EASA	NOTIFICATION OF A PROPOSAL TO ISSUE AN AIRWORTHINESS DIRECTIVE
	<p>PAD No.: 14-103</p> <p>Date: 27 June 2014</p> <p>Note: This Proposed Airworthiness Directive (PAD) is issued by EASA, acting in accordance with Regulation (EC) No 216/2008 on behalf of the European Community, its Member States and of the European third countries that participate in the activities of EASA under Article 66 of that Regulation.</p>
<p>In accordance with the EASA Continuing Airworthiness Procedures, the Executive Director is proposing the issuance of an EASA Airworthiness Directive (AD), applicable to the aeronautical product(s) identified below. All interested persons may send their comments, referencing the PAD Number above, to the e-mail address specified in the 'Remarks' section, prior to the consultation closing date indicated.</p>	
Type Approval Holder's Name : AIRBUS	Type/Model designation(s) : A318, A319, A320 and A321 aeroplanes

TCDS Number :	EASA.A.064
Foreign AD :	Not applicable
Supersedure:	This AD supersedes EASA AD 2012-0055R1 dated 17 October 2012.
ATA 35	Oxygen – Chemical Emergency Oxygen Containers – Modification
Manufacturer(s):	Airbus (formerly Airbus Industrie)
Applicability:	Ai

Appendix 1 – Design A of the Passenger Oxygen Containers affected by this AD

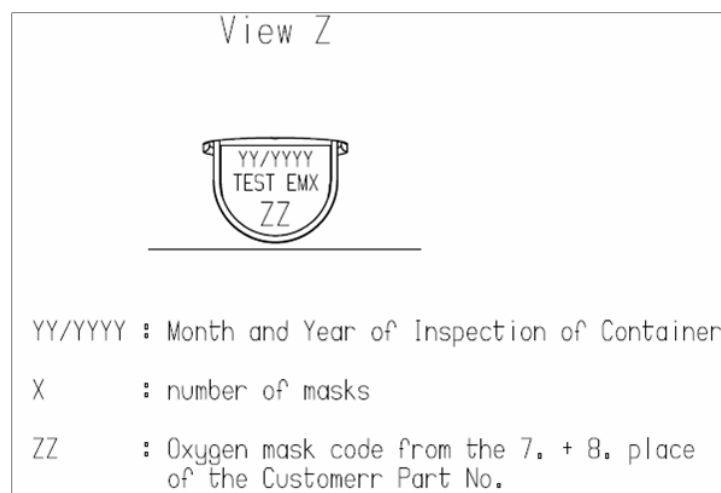
Design A: The placard on the passenger oxygen container test button is as described in Picture A of Appendix 1 of this AD. The Mask configuration ("ZZ" in Picture A) is a number and the test button is as shown in Picture B.
